Addendum No. 2

Subject: Henry Lawton School Classroom Modernization Renovation
SDP Contract Nos. 2022-007-G, 2022-007-P, 2022-007-E

Location: Henry W. Lawton School
4501 Benner Street
Philadelphia, Pennsylvania 19135

This Addendum, dated 17 of February, 2022, shall modify and become part of the Contract Documents for the work of this project. Any items not mentioned herein, or affected by, shall be performed strictly in accordance with the original documents.

1 REFLECTED CEILING PLAN - 1ST LEVEL - ZONE "A"
SCALE: 1/8" = 1'-0"

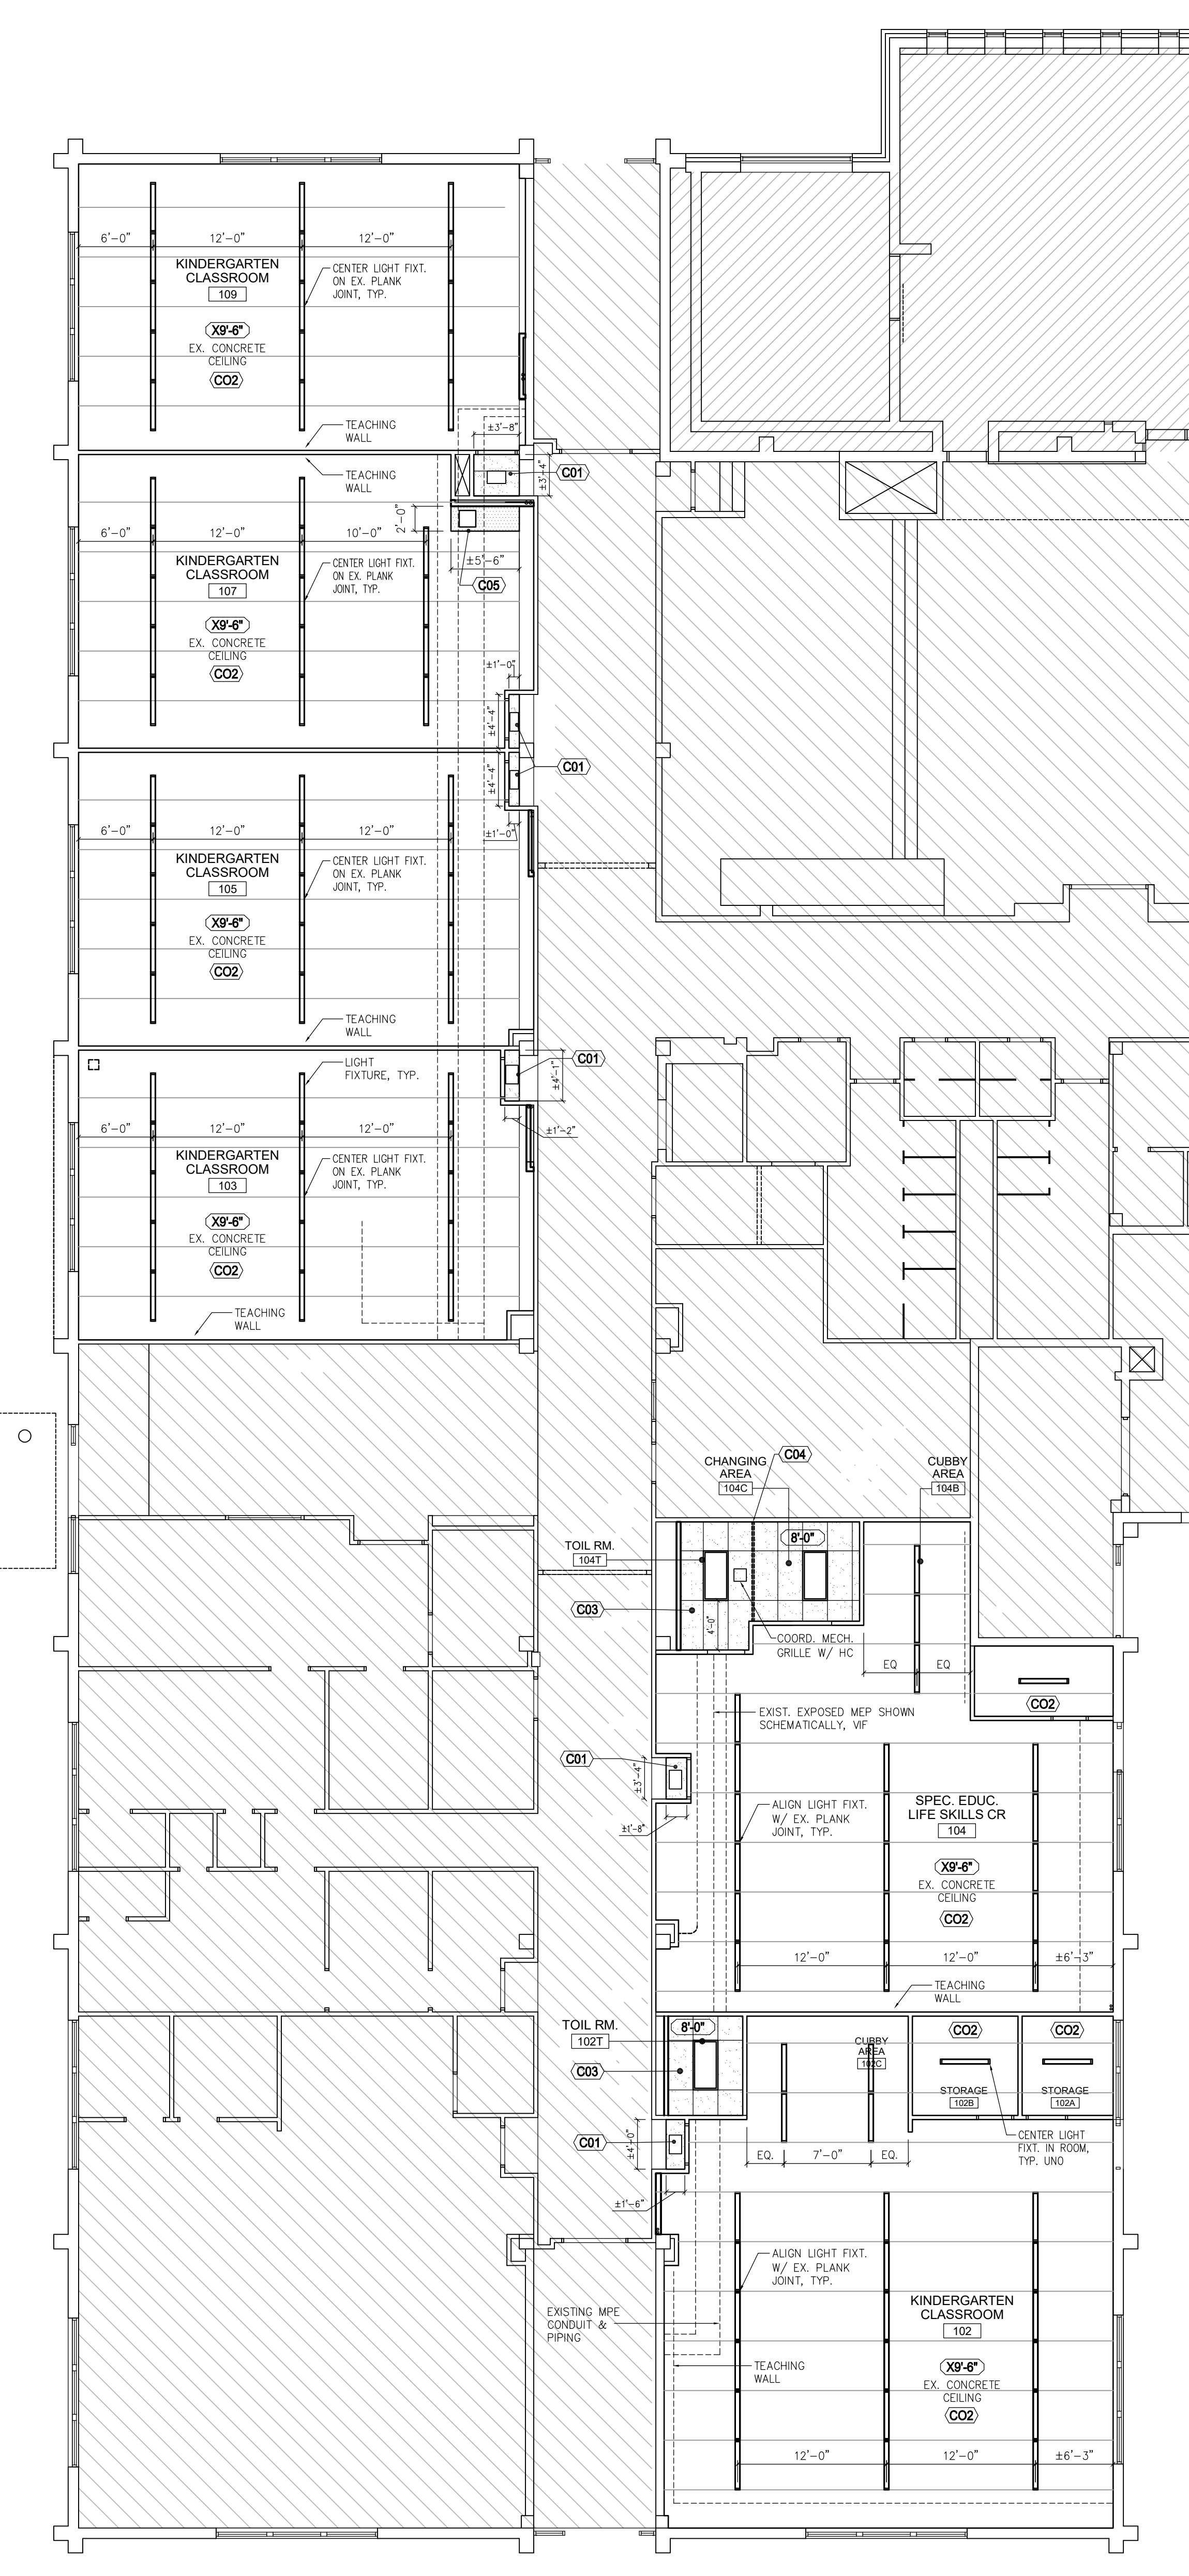
1. MODIFY Keynote C05 as indicated on drawings.
2. REMOVE Existing projects as indicated on drawings

Question 6: There are several locations that call for drywall soffits but does not indicate elevation of soffit. Please clarify

Answer 6: One new drywall soffit will be built in Classroom 107 and is indicated with Keynote C05 (which has been updated, see attached Drawing A120). This soffit should match the height of the existing soffit at +/- 7'-3" (this dimension to be verified in field.) All other drywall soffits are existing to remain and should be patched, prepped, and painted as per keynotes C07 and C08 and notes on interior elevations.

DRAWING NO.
A - 121
SHEET 9 OF 43

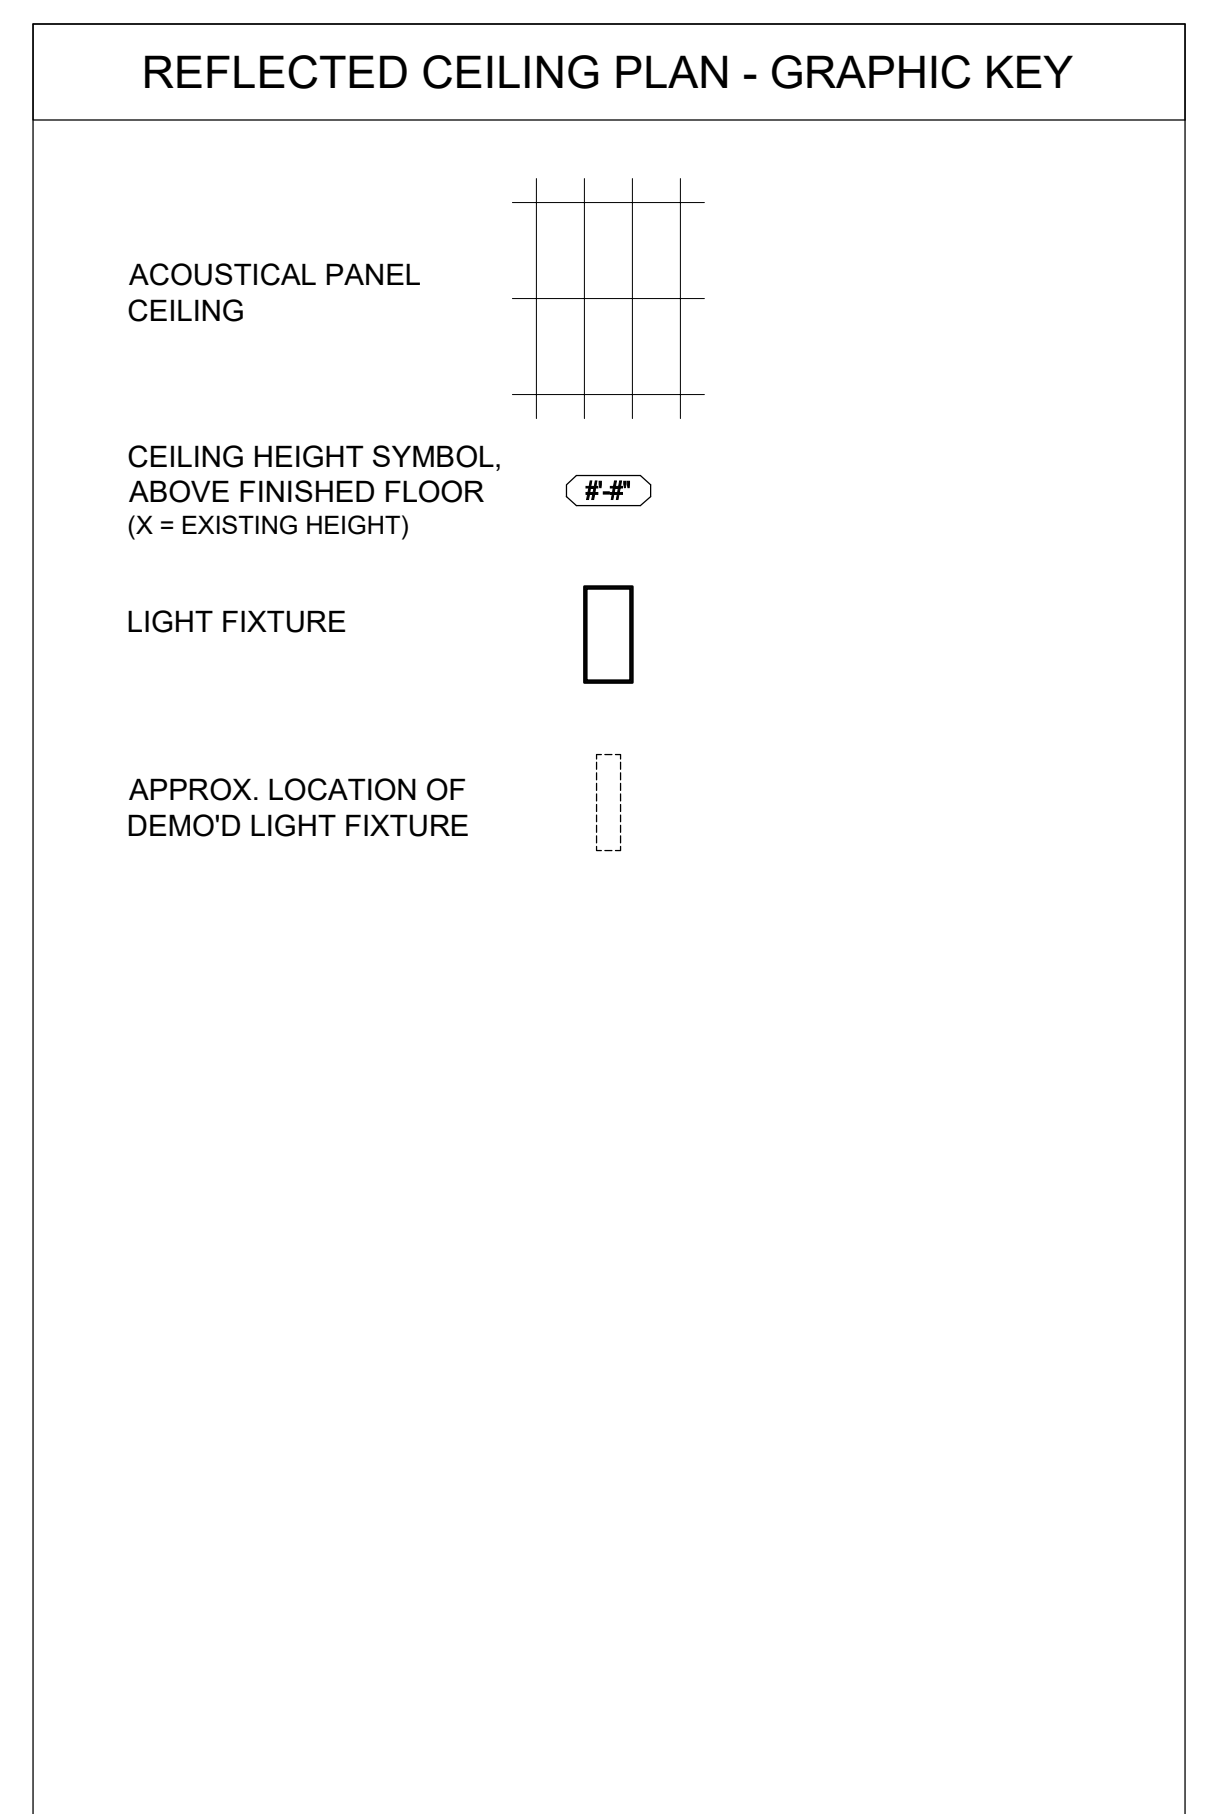
1. REMOVE Existing projects as indicated on drawings

1 FINISH PLAN - 1ST LEVEL - ZONE "A" & "B"
SCALE: 3/32" = 1'-0"

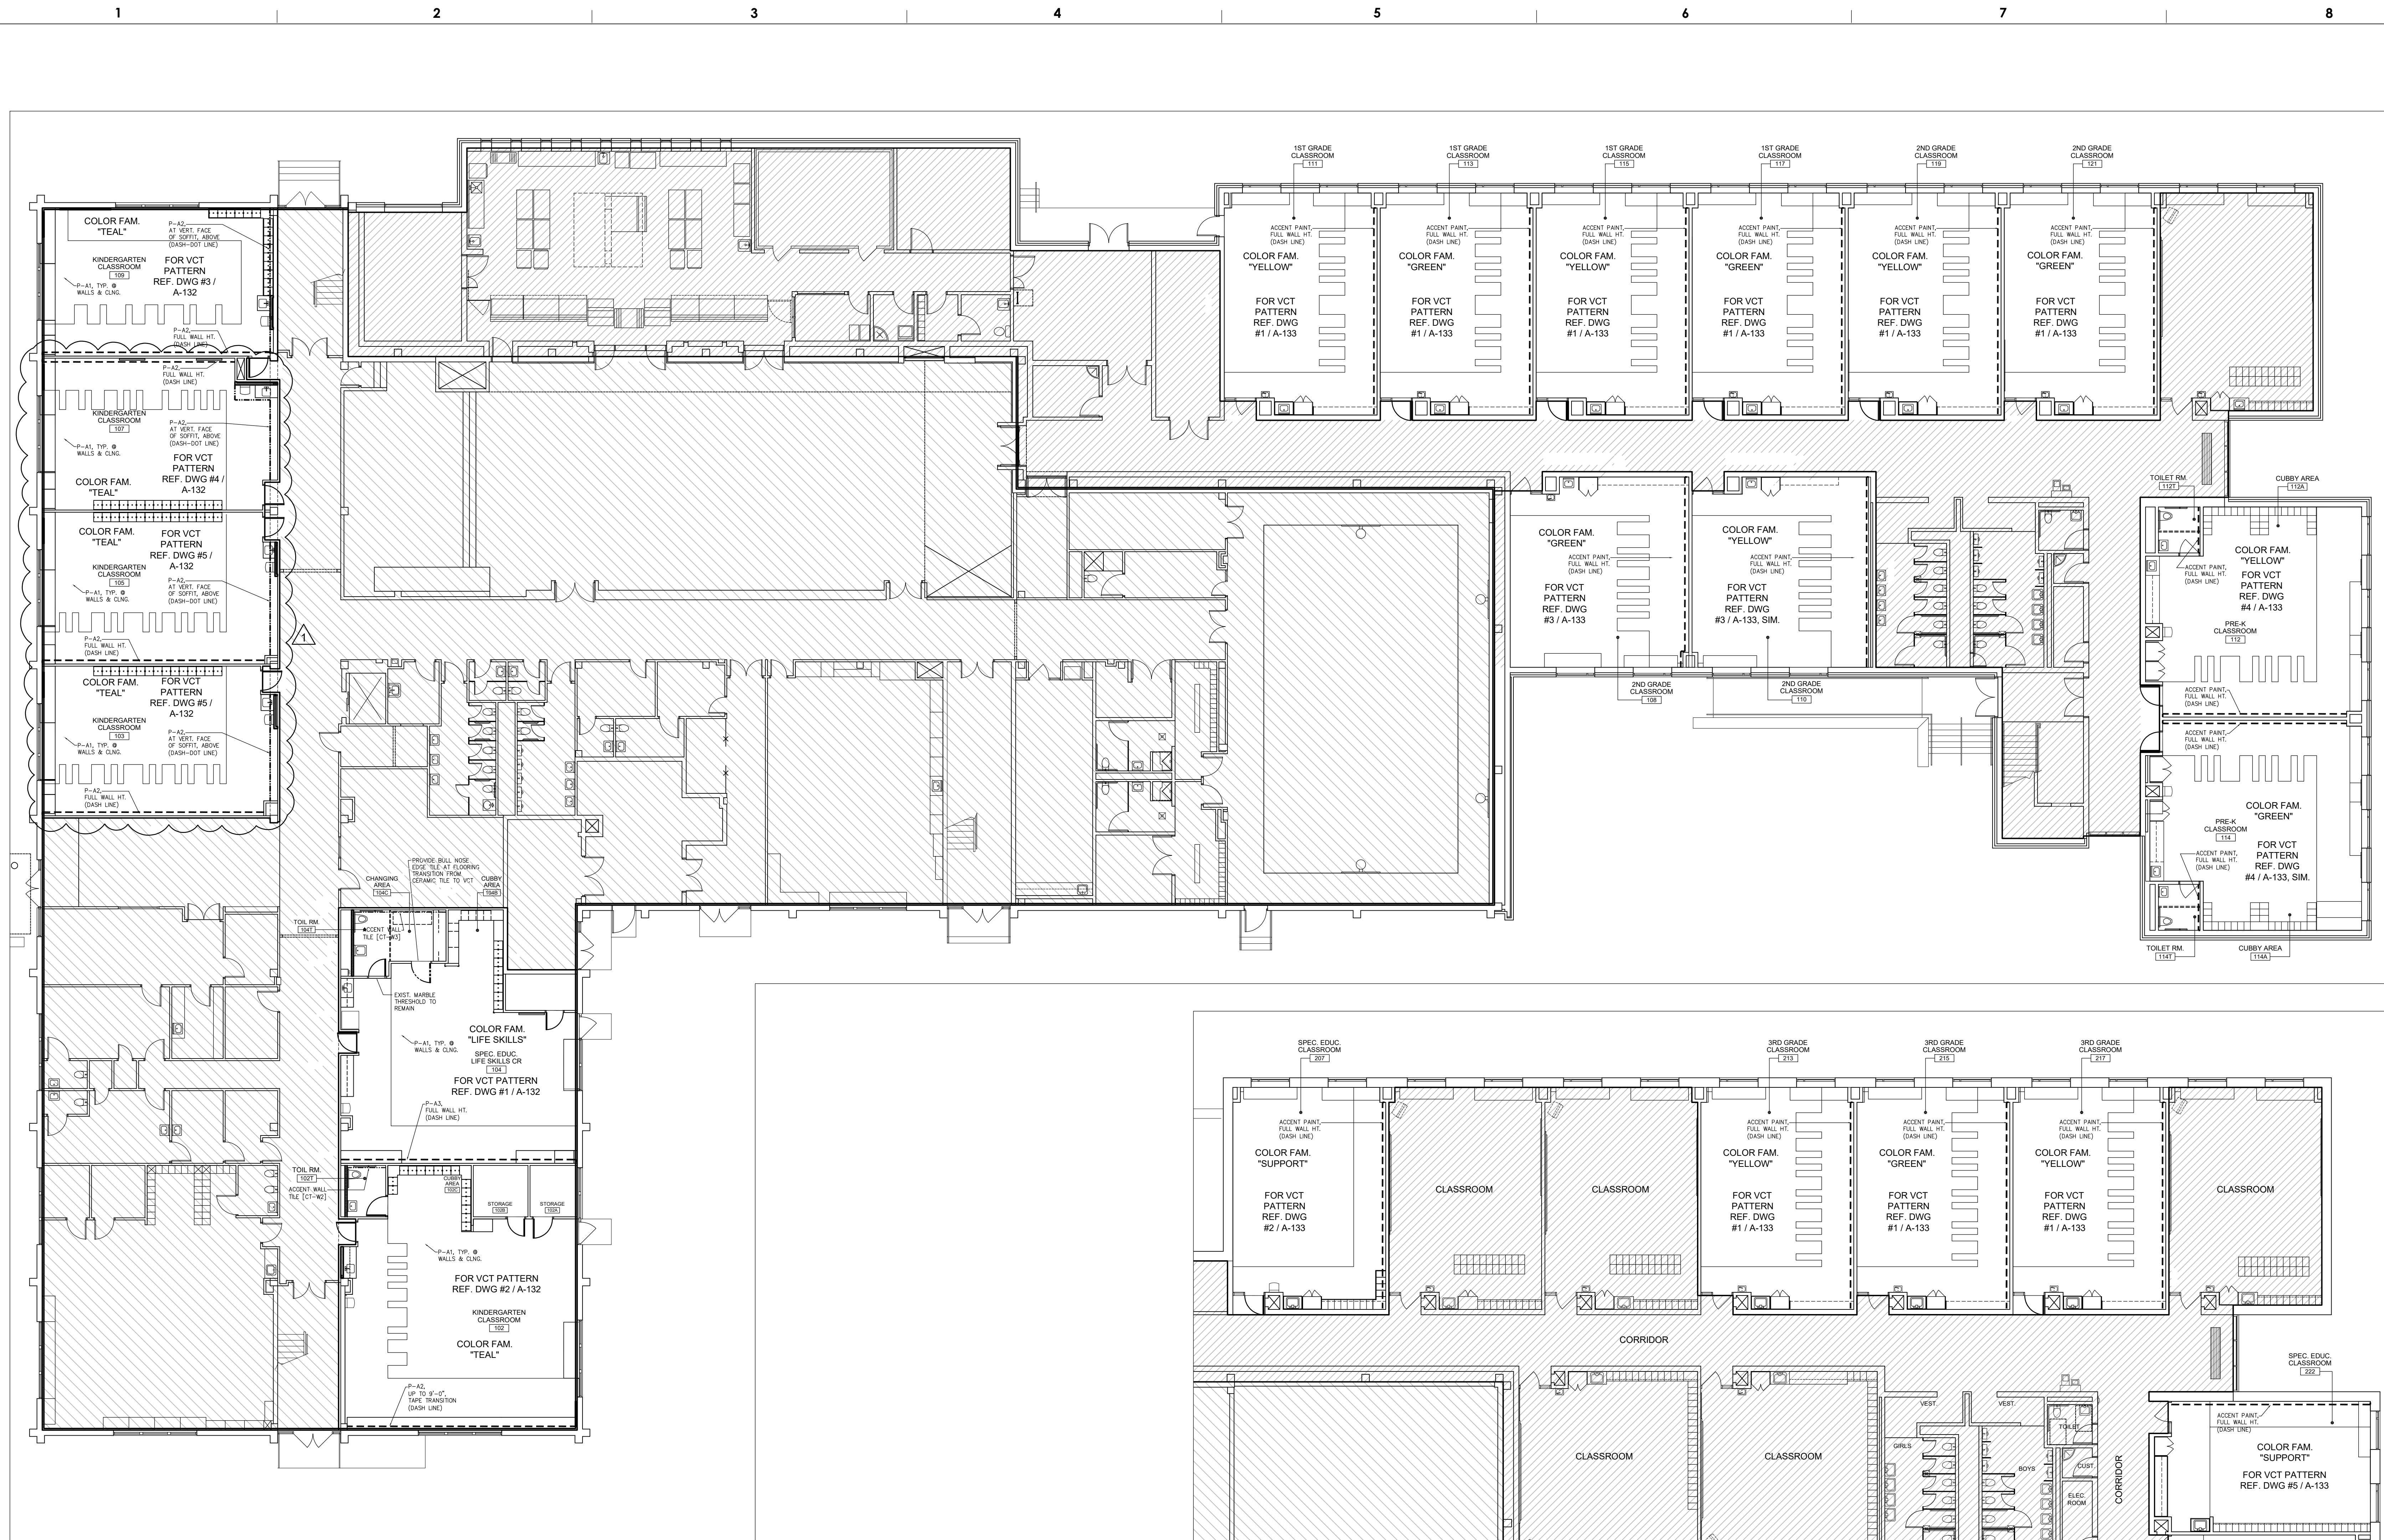
1. MODIFY Detail 1 as indicated on drawings.
